## CVT AIR DUCT PARTS INSTALLATION

## CLUTCH SHOE AND HOUSING INSTALLATION

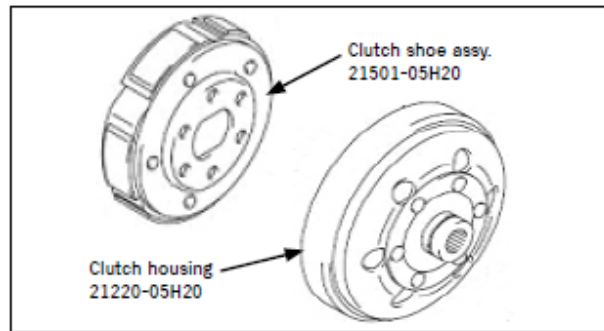
On a customer complaint basis only of clutch judder and/or shoe noise, even after cleaning the dust from the CVT chamber and installing the late type. Air Duct parts, install the AN400AK9 type Clutch Housing (21220-05H20) and Clutch Shoe Assy. (21501-05H20). When installing these parts, follow the procedures Described in the 2007~ AN400 Service Manual. Refer to section 5A. If necessary, clean all CVT parts again according to this Service Bulletin.
